| <b>TECHNICAL NOTE</b> |  |                                  | <b>VELOCITY</b>    |                         |
| <b>Project</b>        | Land Adjoining Antsy, West Sussex      |                                  | <b>Project No.</b> | 22-163                  |
| <b>Subject</b>        | Outline Planning Application Objection |                                  | <b>Document No</b> | TN004                   |

Figure 2-3: Comparison of Walking Routes at A272 Tylers Green Roundabout

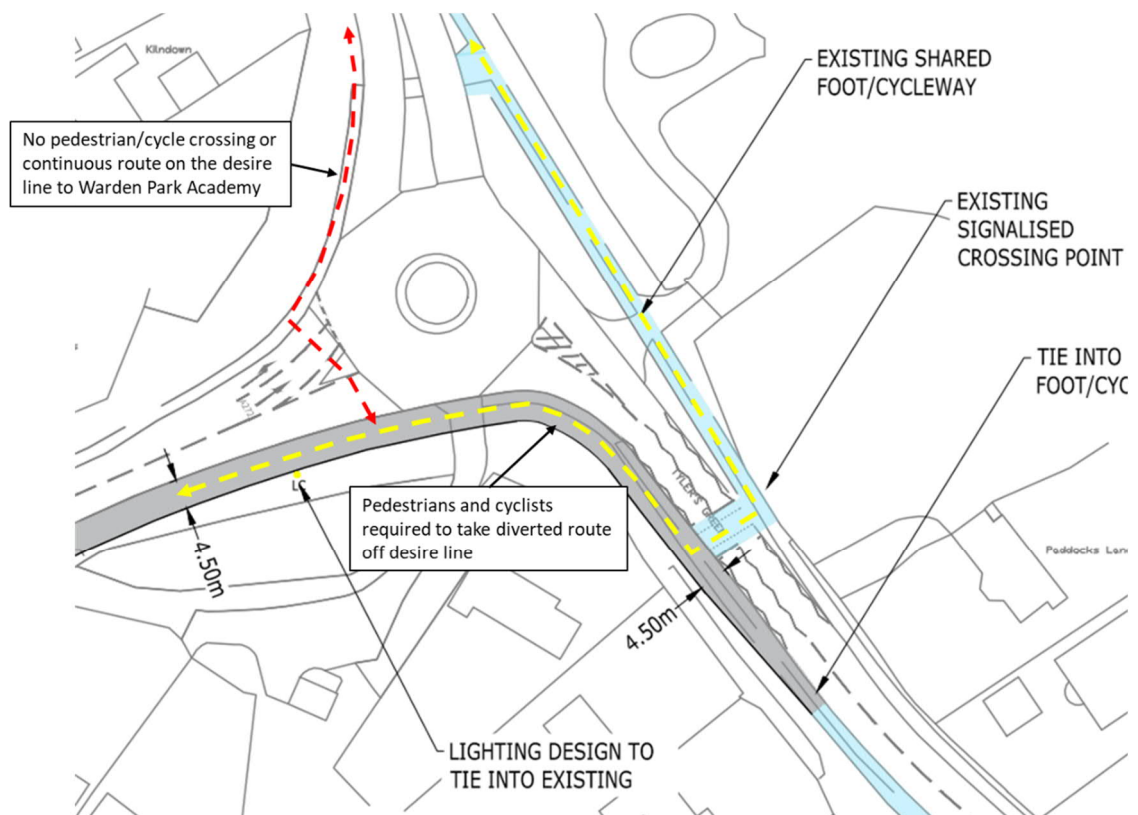
- 2.4.11 However, at the Tylers Green Roundabout, the most direct route to the Warden Park Academy would be to cross the A272 at the western arm of the roundabout and walk/cycle along western side of Broad Street towards the Academy. This is indicated by a red dashed line on Figure 2.3 below.

2.4.12 However, no crossing facilities or continuous pedestrian/cycle route are provided on this desire line route to Warden Park Academy and no improvements to this route are proposed as part of the proposed development. Instead, students walking or cycling to Warden Park Academy via the A272 are required to divert around the southern side of the Tylers Green roundabout and route along the eastern side of Tylers Green and Broad Street. This route is indicated by the yellow dashed line on Figure 2.3 below.

2.4.13 It is evident that the safe route that pedestrians and cyclists are required to use when routing to/from Warden Park Academy does not follow the desire line and requires diversion from the desire line to follow a safe route. This is likely to result in students crossing at an unsuitable and unsafe location on the desire line to avoid significant diversion.

Figure 2-4: ACE TA Figure 3.3

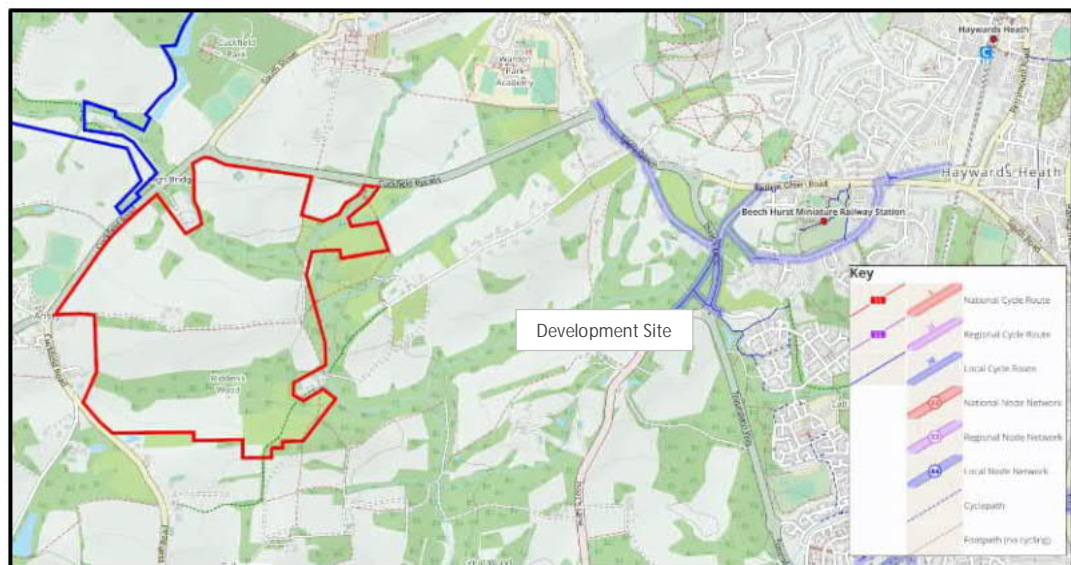
- 2.4.16 The ACE Transport Assessment makes reference to outputs produced by the Mid Sussex Local Cycling and Walking Infrastructure Plan (LCWIP), which denotes a desire line for cyclists between the village of Ansty and Haywards Heath (see Figure 3-4 of the ACE Transport Assessment).
- 2.4.17 Notwithstanding the findings of the LCWIP, Figure 3-3 of the ACE Transport Assessment, reproduced as Figure 2-4, below, demonstrates a clear lack of suitable cycling infrastructure within close proximity of the development site. The absence of suitable infrastructure combined with the nature of local roads is likely to discourage cycling journeys by residents or commuters at the proposed development.

- 2.4.18 The conclusion to Chapter 3 of the ACE Transport Assessment states that:  
 “There is an existing propensity to cycle from Ansty Village, with the primary pole of attraction being towards and East and Haywards Heath”
- 2.4.19 Other than repeating the finding of the LCWIP desire line study, the report does not go on to provide a relevant conclusion on accessibility of the proposed development site by cyclists.

Figure 2-5: Extract: ACE Drawing 2207280-SK05 Rev H 'Cycle Route Improvement Plan'

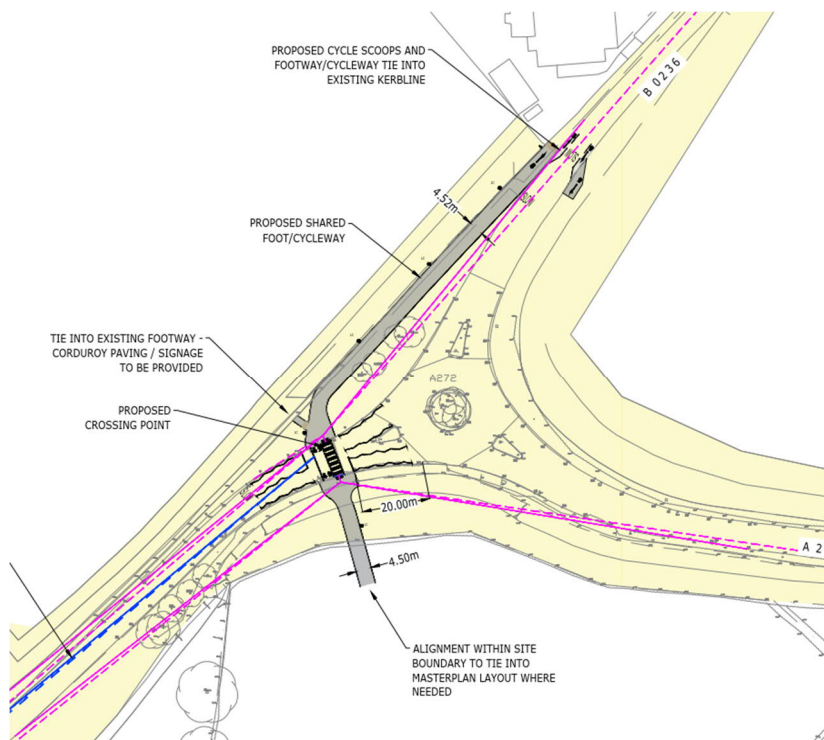
2.4.24 The ACE 'Cycle Route Improvement Plan' shows that just north of the B272/B2036 roundabout cyclists will be required to join the carriageway of the B2036 and no off-carriageway route is provided north of the roundabout to continue the majority of the route towards Cuckfield. It is highlighted that this section of the B2036 is subject to the national speed limit (60 mph) and is therefore not considered to be a safe or suitable route to cycle on carriageway.

2.4.25 It is therefore evident that the proposed development does not provide continuity of the cycle route from the site to Cuckfield and does not provide an appropriate cycle facility on a route which has been identified as a key active travel desire line by the applicant.

Figure 3-1: Census Middle Super Output Area Haywards Heath 009

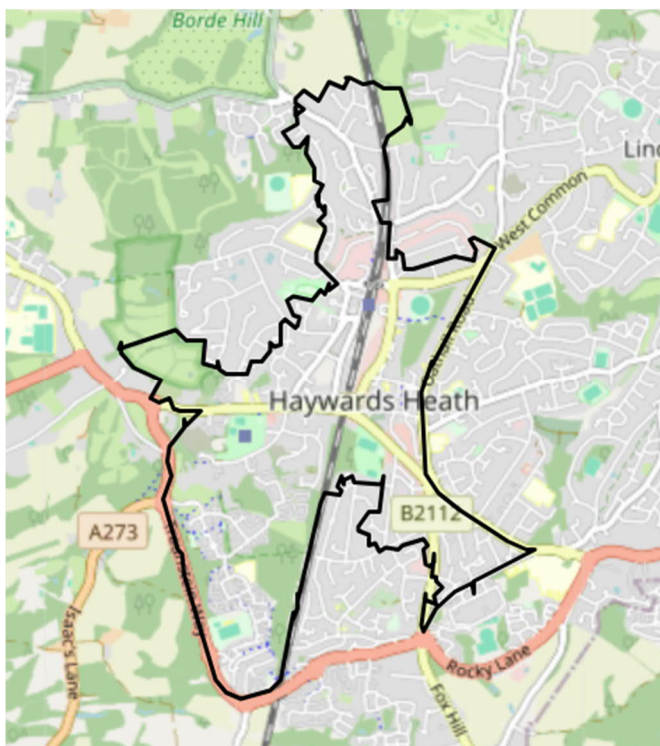
3.2.4 The census output area utilised to assess the mode share of the proposed development has been based on an output area which include Haywards Heath urban area including the town centre, a wide range of shops and services, Haywards Heath railway station and a number of frequent bus routes.

3.2.5 It is evident that the mode share data for residents living in the urban area of Haywards Heath including the town centre and a railway station is not comparable to the location of the development in an isolated rural area with limited access to shops, services, infrequent bus service and no train station. As such the mode share assumptions presented in the ACE Transport Addendum will significantly overestimate likely non-car modes of travel including public transport mode share and underestimate private car usage.
